SUNDRY NOTICES AND REPORTS ON WELLS

Price Federal #1 (E-34)

Project Name: Price Federal No. 1 E-34 Pipeline Reroute

CULTURAL RESOURCE STIPULATIONS

BENSON-MONTIN-GREER DRILLING CORPORATION: PRICE #1-34
PROPOSED PIPELINE SURVEY LOCATED IN THE W/2 OF SECTION 34,
T25N, R2W, N.M.P.M., RIO ARriba COUNTY, NEW MEXICO

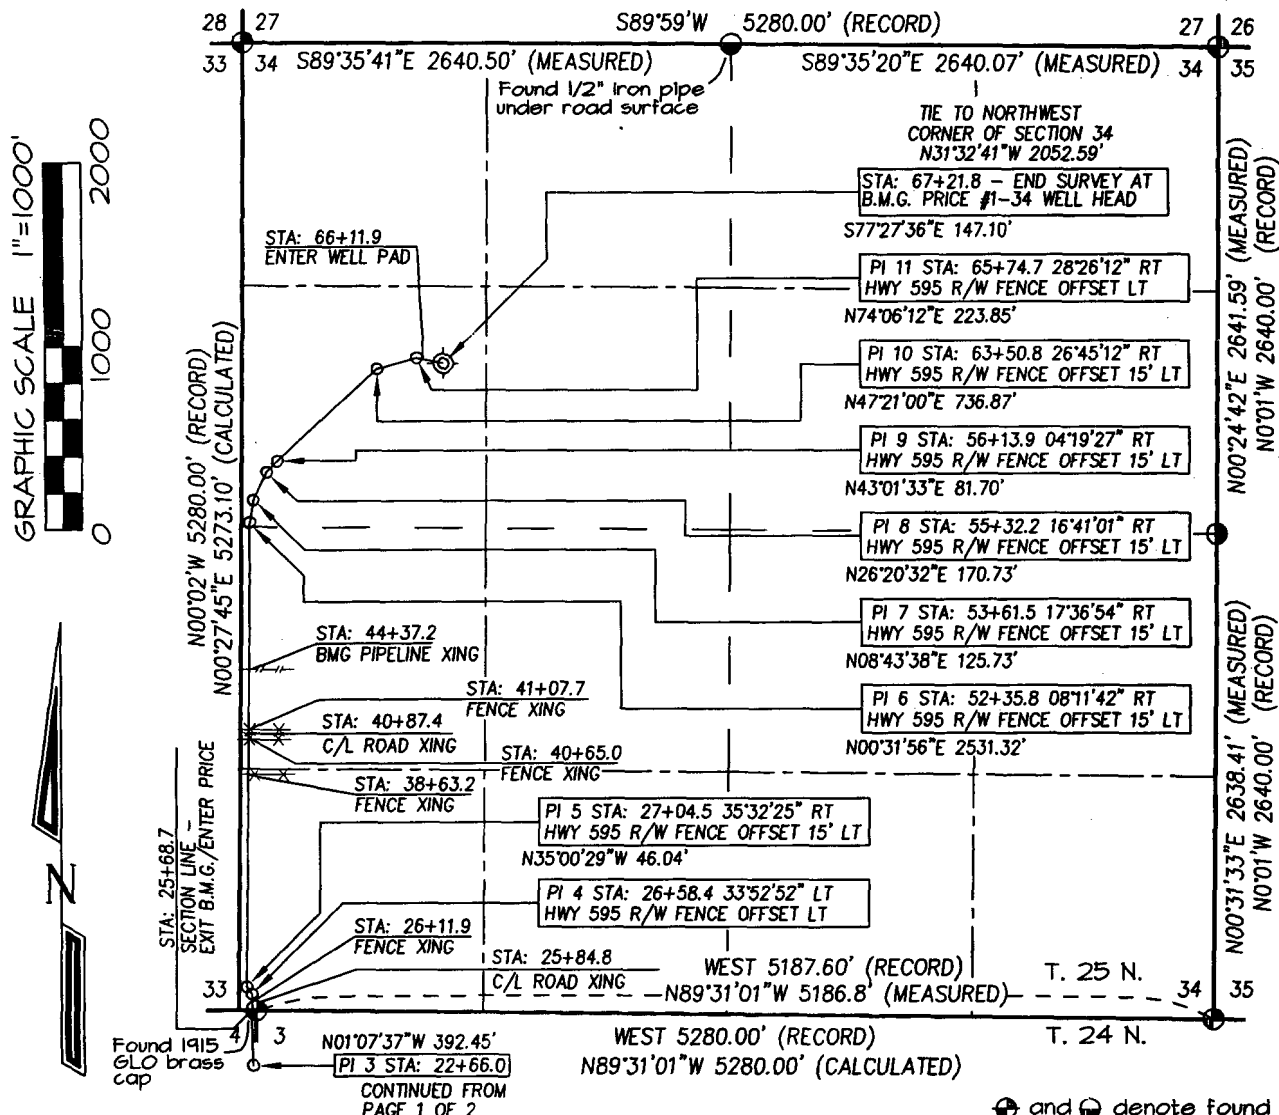
In order to avoid the arc site to the north of the Price Federal #1 well, we have decided to abandon our original plan to go north with our gathering line. We now propose to go south as per attached survey plat. This new route is currently being examined by Salmon Ruins Archeology and we would like to schedule on On-Site at your earliest convenience.

LA 54315 (NM-01-33212): Eligible - pipeline rerouted to previously disturbed area

- * Ensure that the reroute is located at least 8' northwest of the original pipeline centerline extending from BOL to ES 3+50.
- * Ensure that the site protection barrier is located as indicated on the attached map.
- * Observe all surface disturbing activities within 100 feet of site LA 54315.
- * Submit a report of the monitoring activities within 30 days of completion of monitoring unless other arrangements are made with the BLM. These Stipulations must be attached to the report.

LA 54315: The barrier will be placed along the original pipeline centerline extending from ES 0+00 to ES 3+00.
